Service Bulletin

Title: SB 429-205 Bell 429 Condenser Fan Motor Mount Fastener Inspection

Applicability: Bell Helicopter Textron Canada Limited 429 Aircraft equipped with any Air Comm Corporation 429EC-200 or 429EC-202 Air Conditioning Systems. Not applicable to any 429EC-200 or 429EC-202 Systems with SK-429EC-7000 accomplished.

Reference: FAA STC # SR00693DE

Figure 1

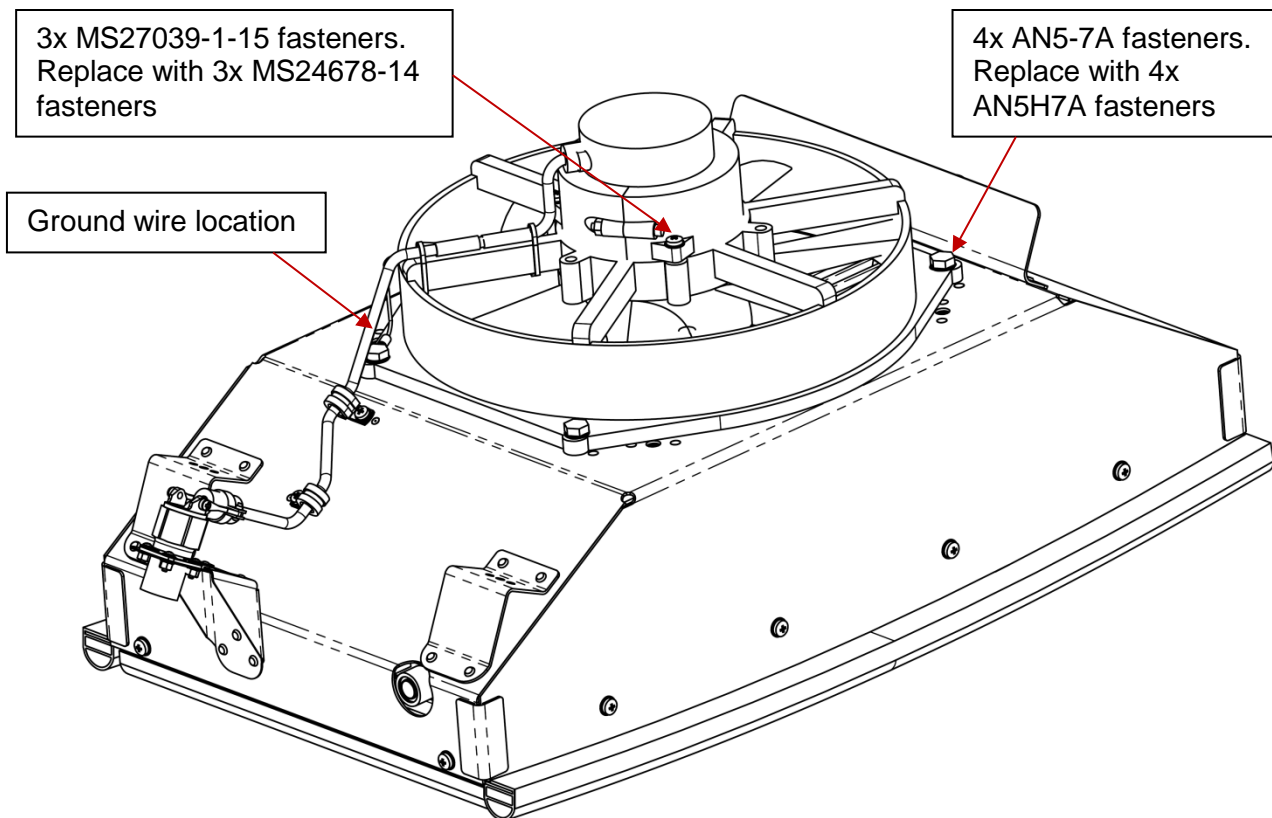
2. Remove the 3x MS27039-1-15 fasteners. Apply Loctite 222 to 3x MS24678-14 fasteners and install in cover fastener holes. Torque fasteners to 20-25 in-lbs. See Figure 1 for location of MS27039-1-15 fasteners.

4. Remove 4x AN5-7A fasteners. See Figure 1 for location of AN5-7A fasteners.
5. Install 4x AN5H7A fasteners. Re-use existing washers. Re-install ground wire as shown in Figure 1. Tighten fasteners to snug plus ¼ turn.

Figure 2

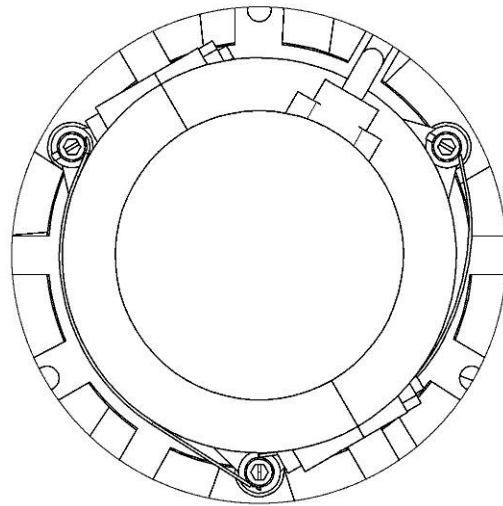
3. Attach AS3510-0224K locking cable or MS20995C32 locking wire to 3x MS24678-14 fasteners as shown in Figure 2, installing per the double-twist method specified in AC 43.13-1B Chapter 7 Section 7.

Figure 3

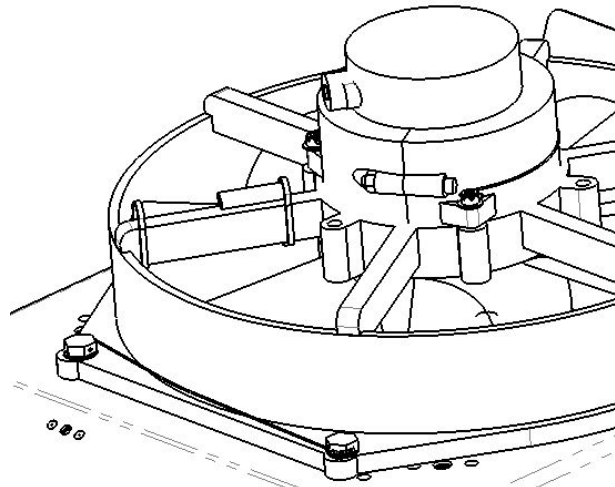
6. Attach 2x AS3510-0224K locking cable or 2x MS20995C32 locking wire to 4x AN5H7A fasteners as shown in Figure 3, installing per the double-twist method specified in AC 43.13-1B Chapter 7 Section 7.
